Subject: CHECK ENGINE LIGHT ON WITH DTC P0421	Bulletin No: 01-010/16
	Last Issued: 04/07/2016

This bulletin supersedes the previously issued bulletin(s) listed below. The changes are noted below in Red beside the change bars.

Previously Issued TSBs:	Date(s) Issued
01-016/15	08/04/15

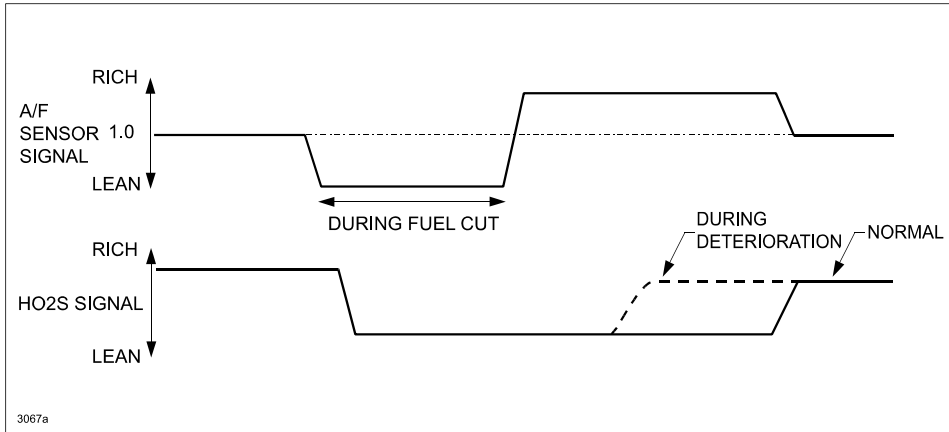
Some vehicles may experience the check engine light on with DTC P0421:00 (Catalytic converter system) without experiencing poor engine performance or misfire (Mitsubishi PCM only).

This is caused by improper control logic of the PCM that may detect false error of the A/F sensor, resulting in false detection of P0421. To correct the problem, the control logic of the PCM has been changed. Catalyst monitor function explanation

- If the catalytic converter purification characteristic deteriorates, the amount of the time until the HO2S detects the voltage on the rich side is shorter compared to the normal purification characteristic as shown. The PCM detects a catalytic converter malfunction using this characteristic.

Verification of Condition of Warm Up Three-Way Catalytic Converter (WU-TWC)

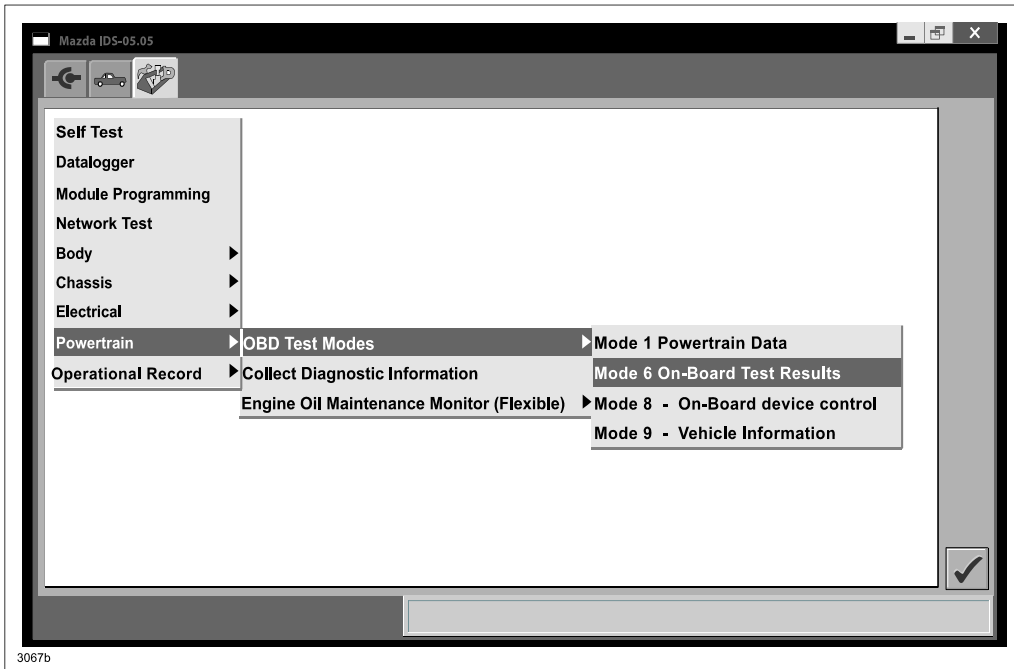
1. Verify the condition of the Warm Up Three-Way Catalytic Converter (WU-TWC) by checking the value “Catalyst monitor bank 1” on MODE6 with M-MDS.
 - a. Go to Powertrain => OBD Test Modes => Mode6 On Board Test Results

b. Go to Catalyst monitor bank 1 => Equivalence Oxygen Storage Component (OBDMID: 21, Test ID: 82)
